Pre-Design Investigation
(Additions)

ADDRESS John St & Stadium Blvd. ZONE ATLAS # L-14 | D31

PROPOSED DEVELOPMENT Add New structure

RE: FIELD INSPECTION FOR ODOR CONTROL STATIONS 4, 19, & 29
(L-14)

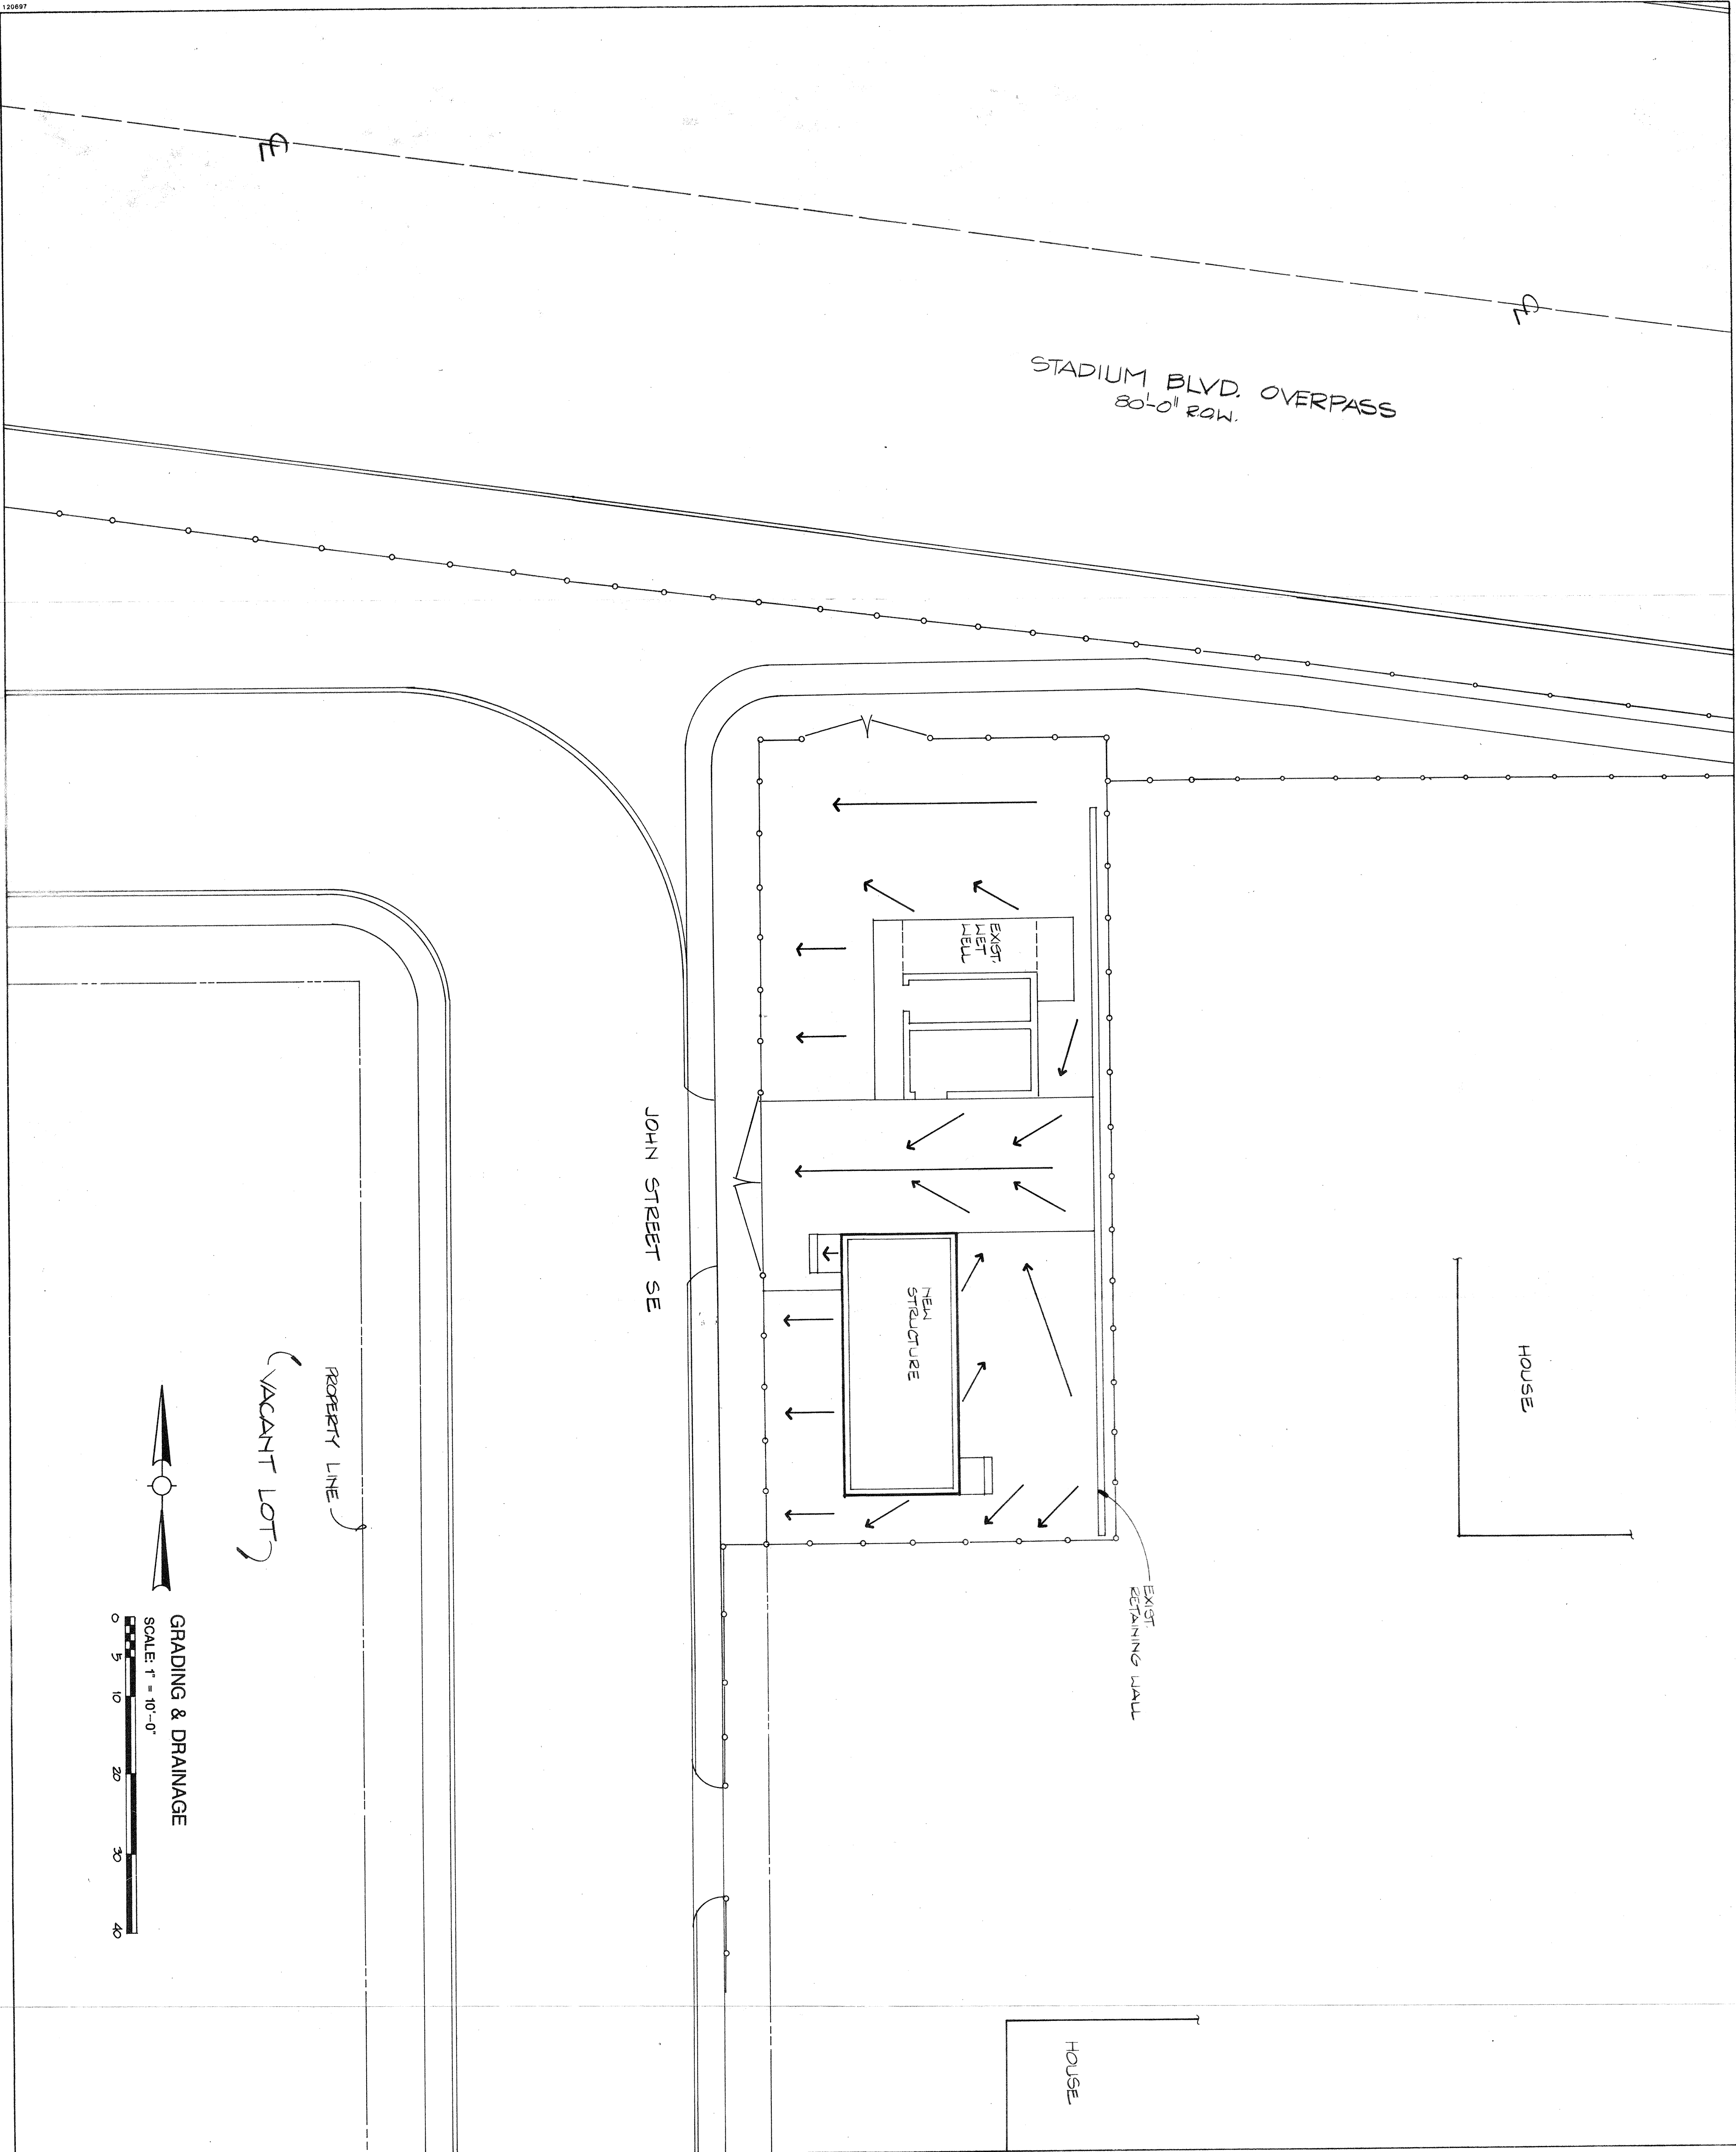
Odor Control Station 19

This site will not need a drainage plan. The site will have minimum impact on downstream facilities. Flows from the site need to be directed to John Street.

Also, off-site flows cannot be blocked but must be conveyed through the property.
